ACCESSION NBR: 9411070415 DOC. DATE: 94/10/31 NOTARIZED: NO DOCKET #
 FACIL: 50-305 Kewaunee Nuclear Power Plant, Wisconsin Public Service 05000305
 AUTH. NAME AUTHOR AFFILIATION
 SCHROCK, C.A. Wisconsin Public Service Corp.
 RECIPIENT NAME RECIPIENT AFFILIATION
 Document Control Branch (Document Control Desk)

SUBJECT: Forwards addl info on third 10-yr ISI plan submitted by util
 931216 ltr, in ref to NRC 940831 request.

Docket 50-305
Operating License DPR-43
Kewaunee Nuclear Power Plant
Additional Information on Third Ten-Year Interval Inservice Inspection Plan

**Re: Additional Information on Third Ten-Year
Interval Inservice Inspection Plan**

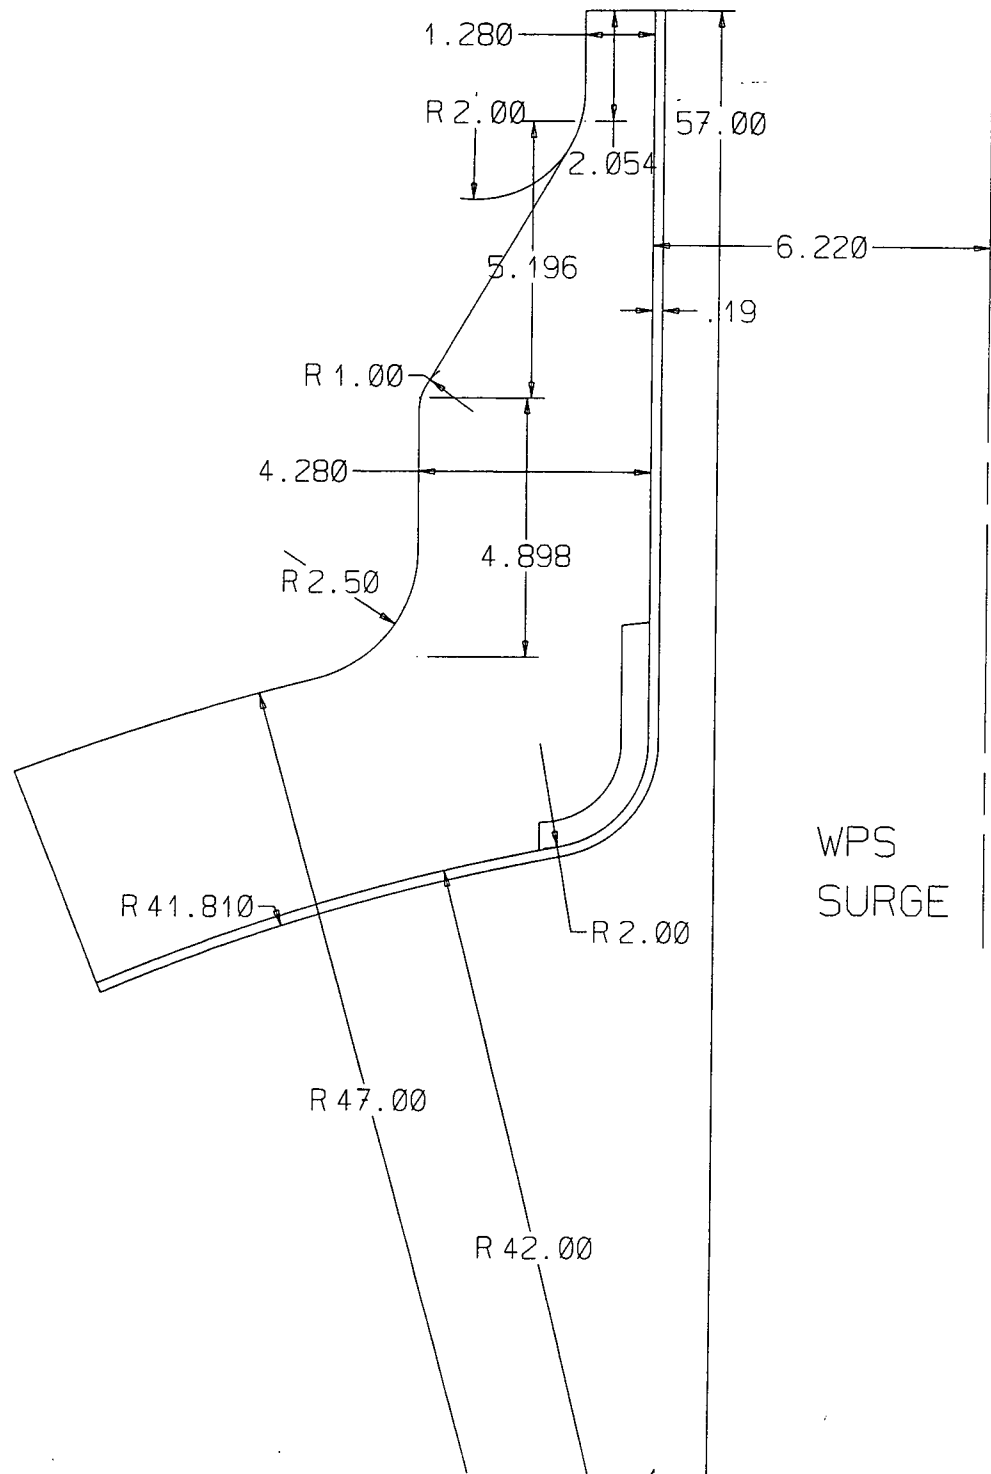
Relief Requests RR-1-3 and RR-1-4 apply to the ultrasonic examination of the pressurizer nozzle inner radius sections, and steam generator hot leg and intermediate leg nozzle inner radius sections, respectively. WPSC has generically described several obstacles associated with these volumetric examinations and has, in some cases, proposed visual examinations as alternatives. Ultrasonic methods and techniques have improved to the point that the bases cited by the licensee may no longer be obstacles to the performance of the required examinations at Kewaunee Nuclear Power Plant. Please provide sketches of the subject nozzle inner radius sections and discuss why a "best effort" volumetric examination should not be included as part of the proposed alternative examination.

It has been WPSC practice to pursue the development of advanced NDE techniques and to perform examinations when and where possible for cases where relief is requested on the basis of technology limitations. Shortly after submitting the Third Interval ISI Plan to the NRC, WPSC contracted Westinghouse Electric Corporation to develop techniques and calibration blocks for ultrasonic examination of the pressurizer nozzle inner radius sections. The Westinghouse Electric Corporation ultrasonic examination procedure has been written to satisfy the code requirements. Therefore, WPSC has removed pressurizer safety nozzle inner radius P-IR8, pressurizer safety nozzle inner radius P-IR9, pressurizer relief nozzle inner radius P-IR10, and pressurizer spray nozzle inner radius P-IR11 from relief request No. RR-1-3. The revised relief request is submitted in Attachment 2. Relief is still requested for the pressurizer surge nozzle inner radius section due to access restrictions caused by the heater penetrations and wiring and other limitations discussed in the relief request.

- Technique drawing of the pressurizer surge nozzle; and
- Technique drawing of a series 51 steam generator primary nozzle.
